RHINO
CASTLE VALLEY MINING LLC

#2 Belt Conveyor Disturbed area expansion TS-13 & TS-5 amendment Submittal, Castle Valley Mining, LLC, C/015/0025

Permittee: Castle Valley Mining, LLC
Mine: Bear Creek Mine **Permit Number:** ACT 015/0025
Title: TS-5 & TS-13 Amendment

Description, Include reason for application and timing required to implement:
Modify TS-13 & commit to coal clean up on TS-5

BEAR CANYON | PLATE 2-3F

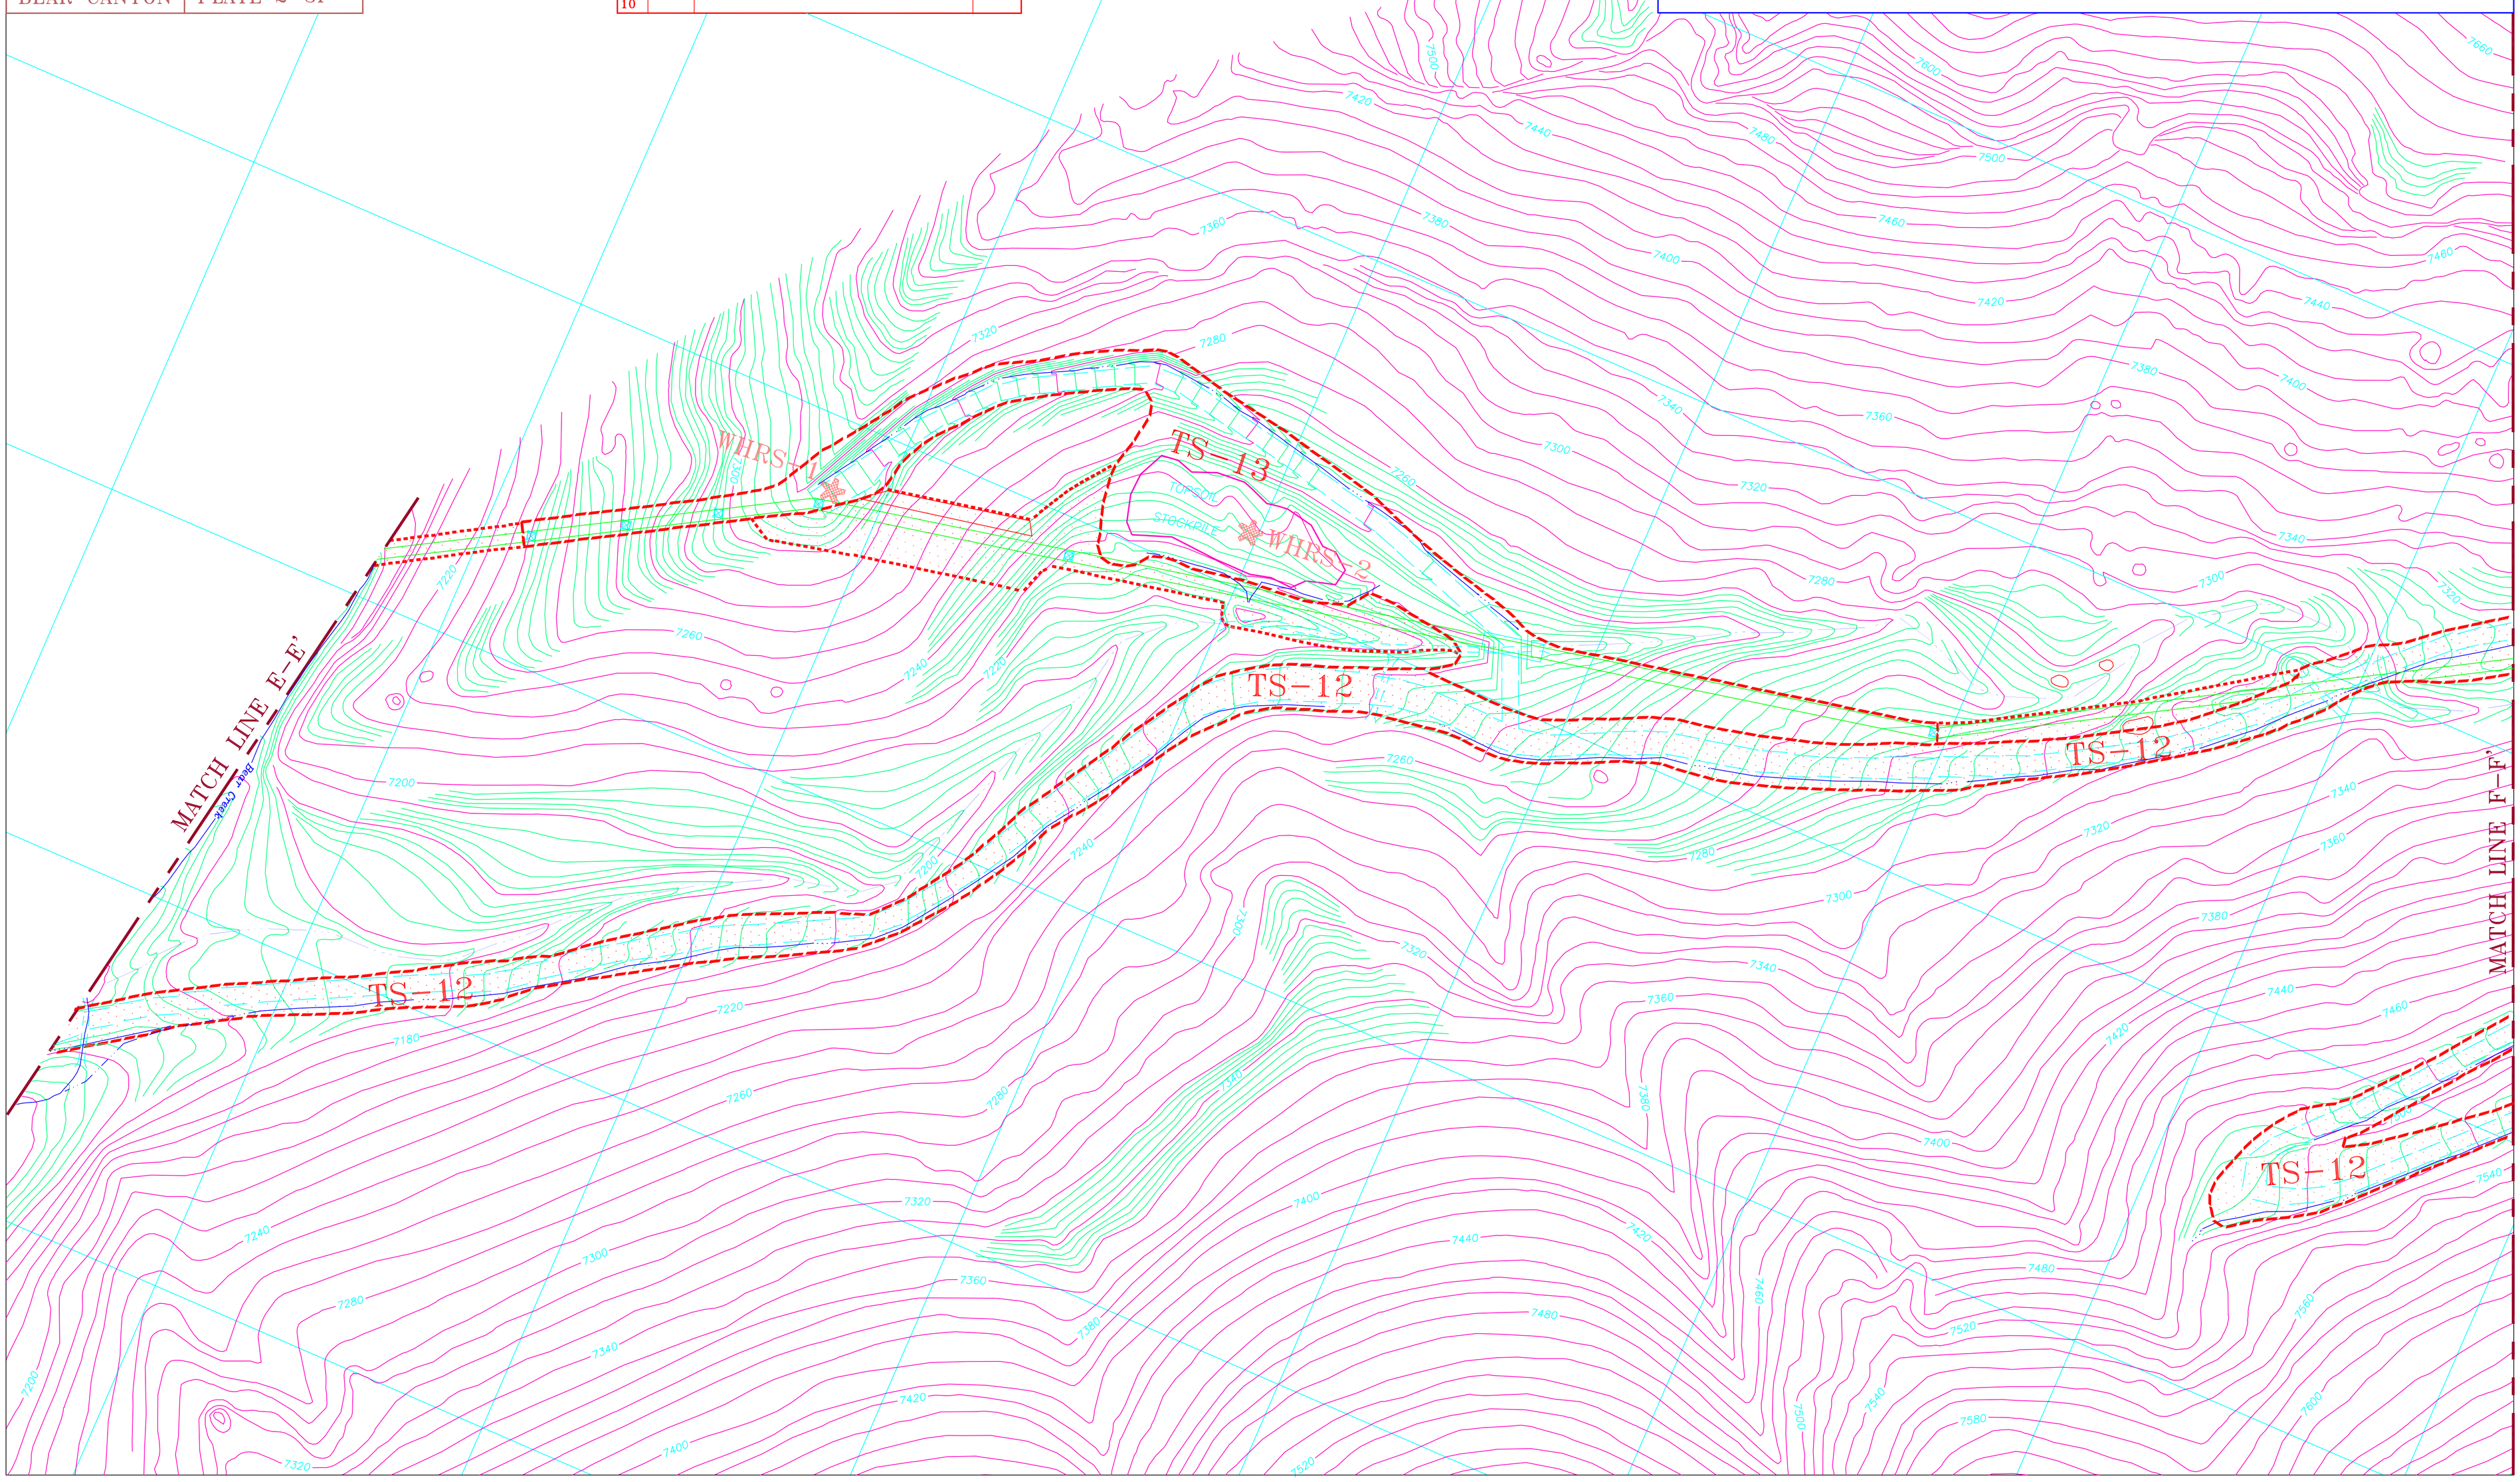
This area modified 8-1-2019 to reflect the modification of an expansion of disturbed area boundary located on Plate 2-3F. Belt conveyor spillage frequent in this area and will be cleaned up upon 4" or more coal spillage weather permitting. South side boundary line will be lined with

straw bales to contain any coal spillage. Area too steep to recover any topsoil. Straw wattles will be placed where needed on the slope to prevent erosion. This area including expansion will be revegetated upon final reclamation.

BEAR CANYON | PLATE 5-2F

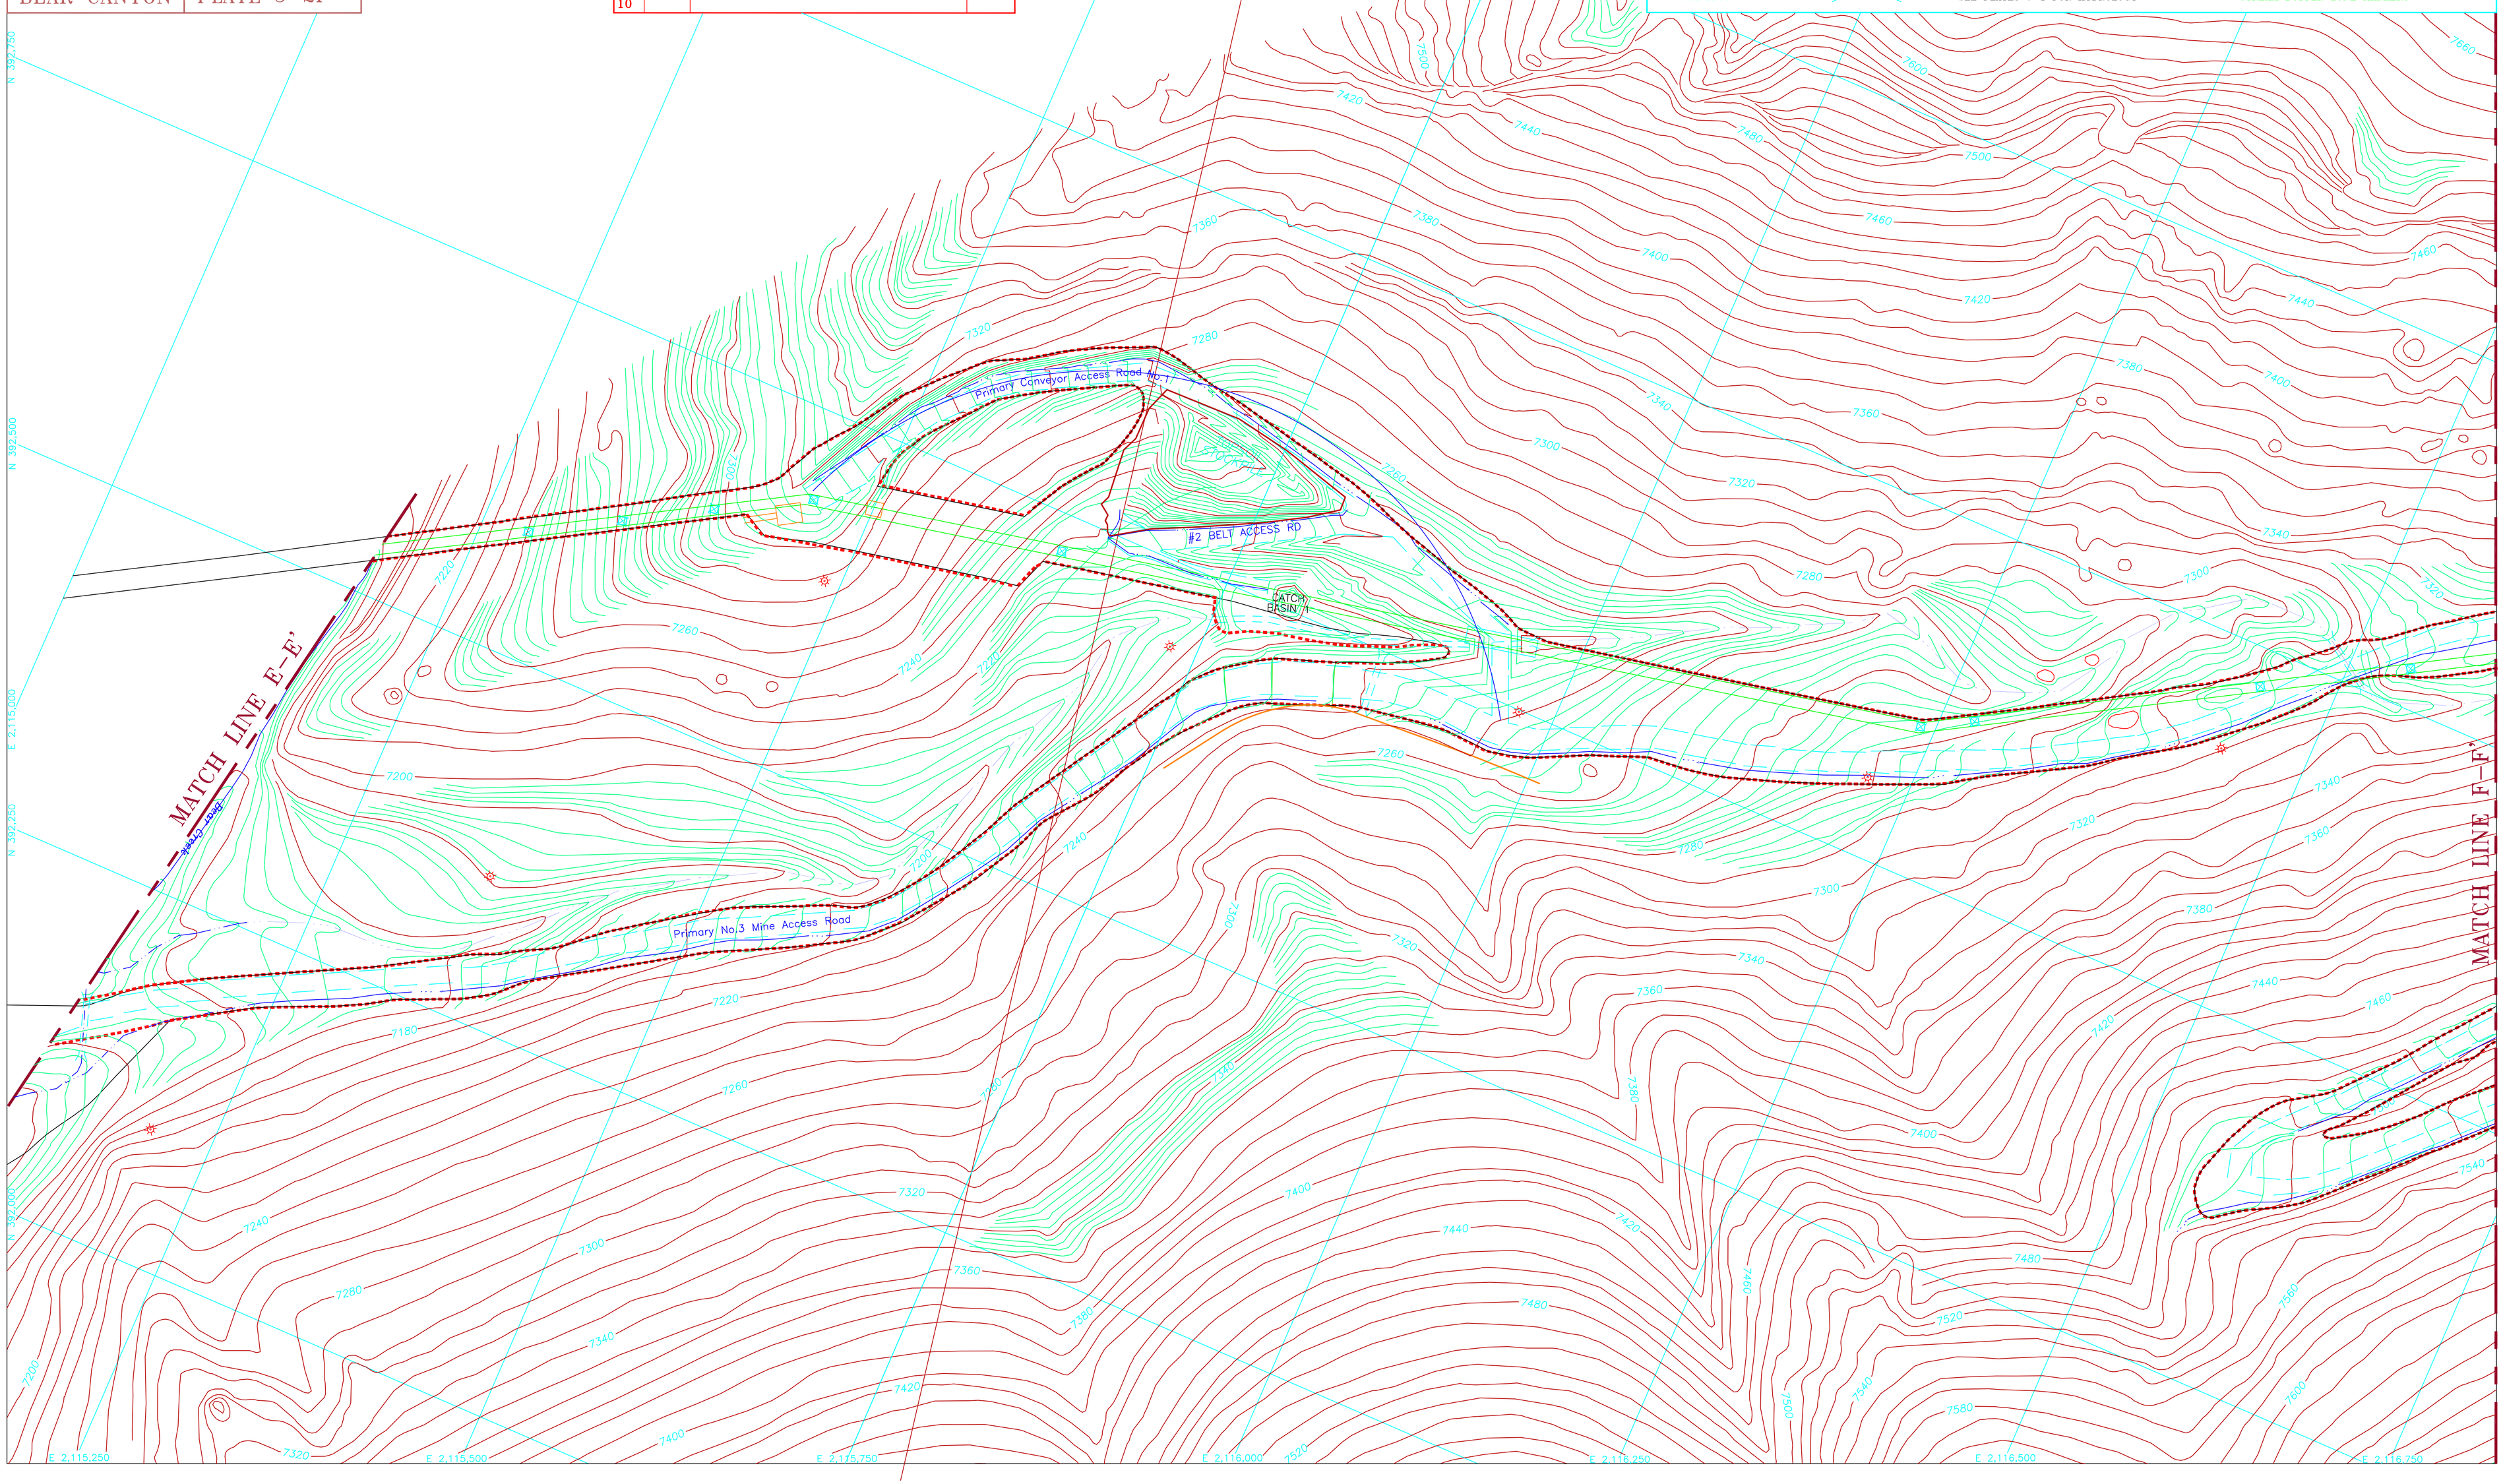
REV.	DATE	REMARKS	APPR.
1	6/25/01	WHR surface facilites added (SR98-1)	7/03/01
2	8/01/02	Changed name from 2-4F to 5-2F	12/8/05
3	5/09/16	Revised topsoil pile & road	
4	4/30/18	Revised topsoil pile Outline	
5	8/7/19	Revised disturbed area boundary	
6			
7			
8			
9			
10
